To: Plan Holders for Improvements to the
Springfield-Branson National Airport
Springfield, Missouri
MoDOT Project No. AIR 126-092A1
West Kearney Terminal Parking Lot and GA Redevelopment

Transmitted herewith is **Addendum No. 2** to the Contract Documents, Plans and Specifications dated December 9, 2013 for Improvements to the Springfield-Branson National Airport, Springfield, Missouri, MoDOT Project No. AIR 126-092A1.

**ADDENDUM NO. 2
TO
CONTRACT DOCUMENTS, PLANS AND SPECIFICATIONS
FOR IMPROVEMENTS TO THE
SPRINGFIELD-BRANSON NATIONAL AIRPORT
SPRINGFIELD, MISSOURI
MoDOT PROJECT NO. AIR 126-092A1**

SHEET NAME
E403
SHEET NO.
122 of 125

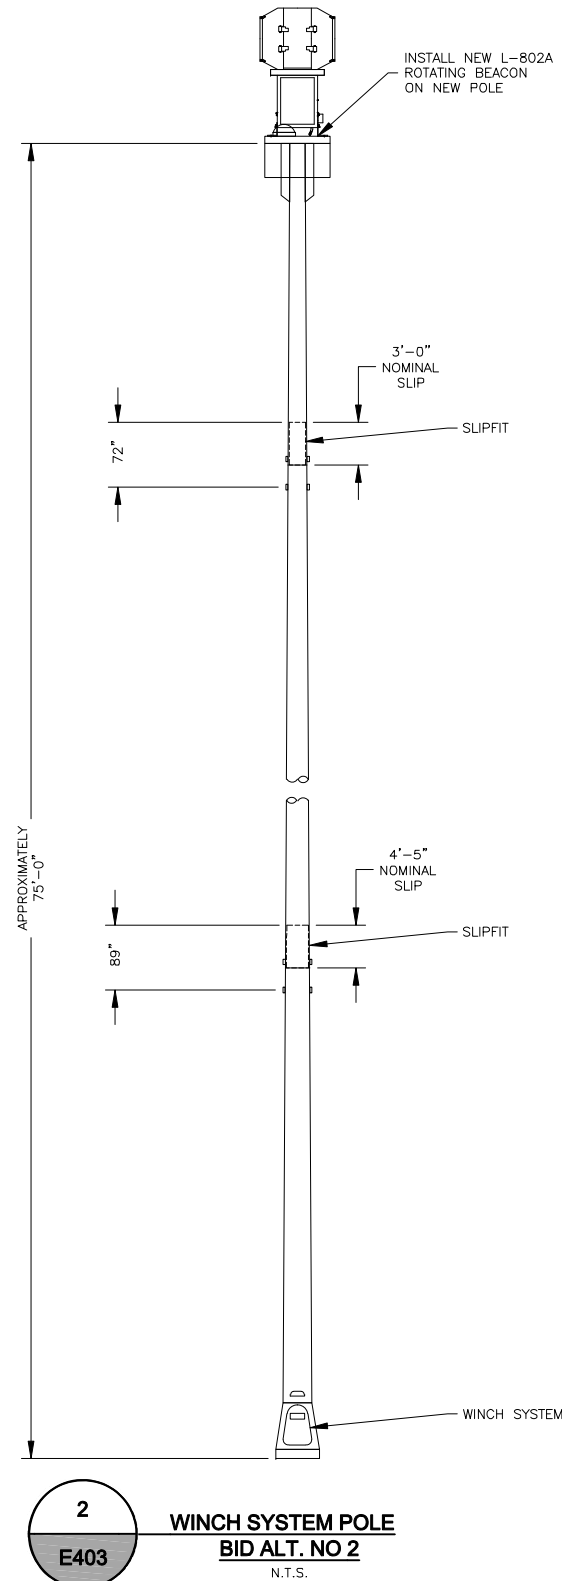
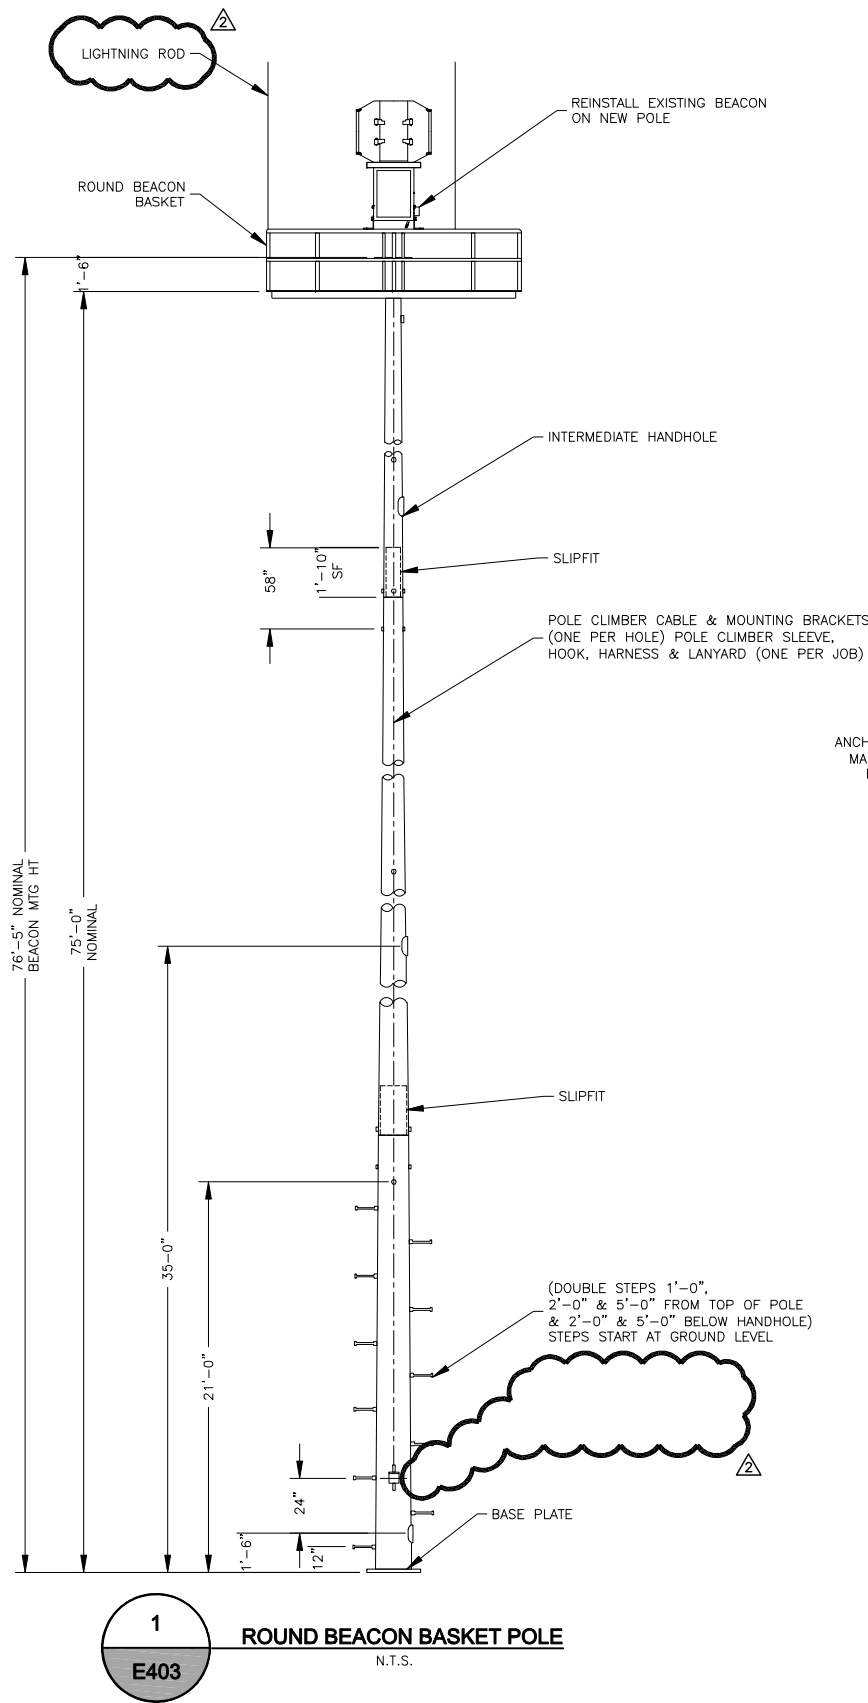
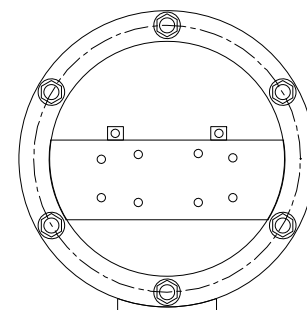
- a) The dimension on Sheet E403, Detail 2 shows a 75 foot pole however the note states the Contractor is to provide a Millerbernd 16-90HRIHI-BEACON-GV/OW- Winch System which indicates a 90 foot pole?

- a. See revised sheet E403, for updated note.
- b) Will the fly ash be paid by the ton or will it be a fixed amount?
 - a. The MO-155b Fly Ash- Type C will be paid by the ton and is associated to the MO-155a Fly Ash Treated Subgrade – 12 Inches. Please see updated proposal sheets for revised quantities of MO-155b.

DETAILS FROM MILLERBERND
CONTRACTOR TO PROVIDE MILLERBERND
16-75FP-RBB/86 BEACON POLE WITH
ROUND BEACON BASKET OR APPROVED EQUAL

DETAILS FROM MILLERBERND
CONTRACTOR TO PROVIDE MILLERBERND
16-75HRHI-BEACON-GV/OW-H WINCH SYSTEM
POLE OR APPROVED EQUAL
